**INTERNATIONAL COURT OF JUSTICE
GABČÍKOVO-NAGYMAROS PROJECT
(HUNGARY/SLOVAKIA)**

REPLY

**SUBMITTED BY THE
SLOVAK REPUBLIC**

**REBUTTAL OF VOLUME 2 OF THE HUNGARIAN
COUNTER-MEMORIAL**

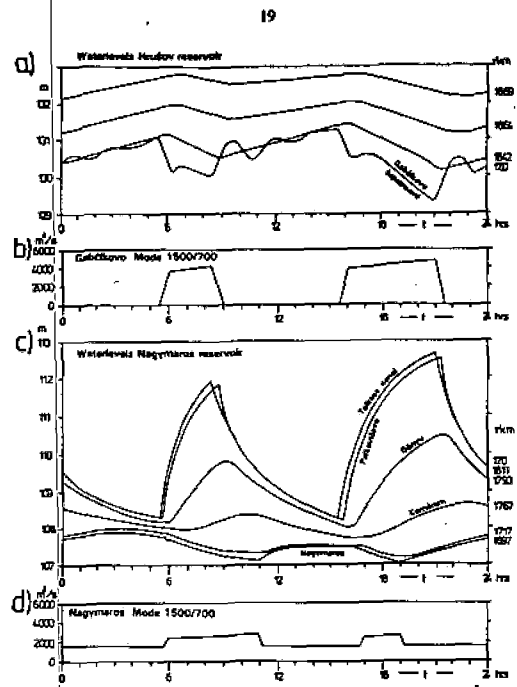
- (2) *The Nagymaros power plant was also supposed to operate on a peaking mode (Figure 2.5).*

Figure 3.6: Change in the chlorophyll-a content of Szap due to the Original Project and Variant C (assuming historical records of hydrology and meteorology to demonstrate variability)

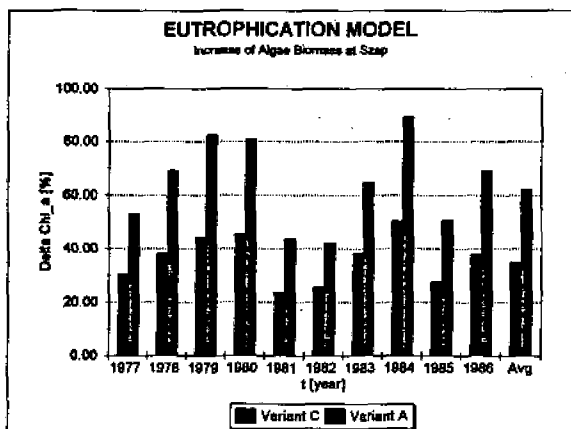
- (2) *The increase in the annual biomass as an impact of the Dunakiliti Reservoir (expressed in terms of chlorophyll-a) ranged between 45% and 90%, reflecting also the role of the hydrologic regime and meteorological condition (Figure 3.6).*

Figure 4.5: Impacts of the Original Project on the natural vegetation of the Szigetköz

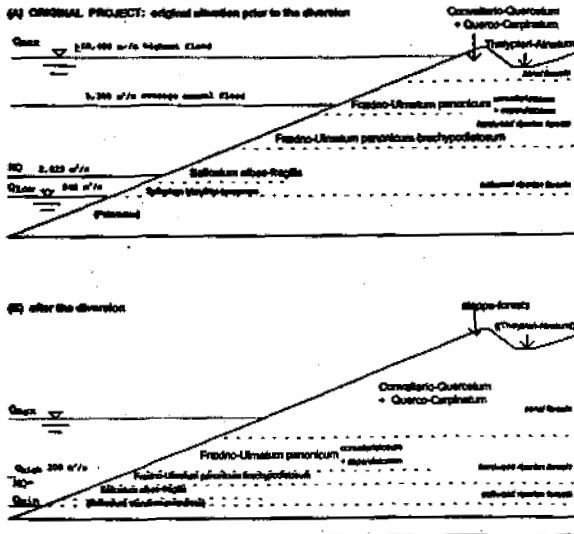
(12) The impacts of the Original Project on the wetland habitats of the Szigetköz would be quite similar, though their species composition is slightly different (Figure 4.5).

- (1) *Figure 4.5: Impacts of the Original Project on the natural vegetation of the Szigetköz.*

- (4) *Summarising, the effects of Variant C on the floodplain vegetation do not differ seriously from those predicted for the Original Project (see Figure 4.5). The actual increase of the everyday water levels is insufficient for the further existence of the floodplain habitats.*

Such alleged impacts of the "Original Project", disregarding the remedial measures that were developed, are once again not relevant to Hungary's claims of ecological necessity in 1989 or 1992, made in relation to a developed and developing Project.

Figure 5.1 The effect of the lowering of the groundwater table on capillary rise

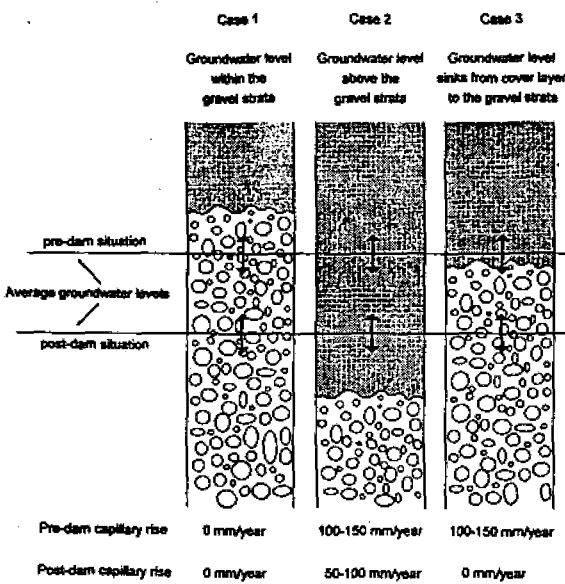
- (2) (3) *Case 3 (Figure 5.1). Groundwater is fluctuating at present within finer-textured sediment, but as a consequence of the changes in the hydrology of the Danube-system (e.g. reduction of groundwater-supply from the original riverbed and from the connecting branches and meanders) the groundwater-table will sink to the gravel strata. This effect may extend up to about 30% of the impact area.*

"30% of the impact area": Again, it is stressed that the impact area in Hungary is only Szigetköz. According to HC-M, Vol. 4, Annex 20, the area affected by loss of groundwater is 4,200 hectares (at p. 771) out of the 22,000 hectares used in Szigetköz for agricultural production (at p. 768). This gives a figure of 19%, not 30%.
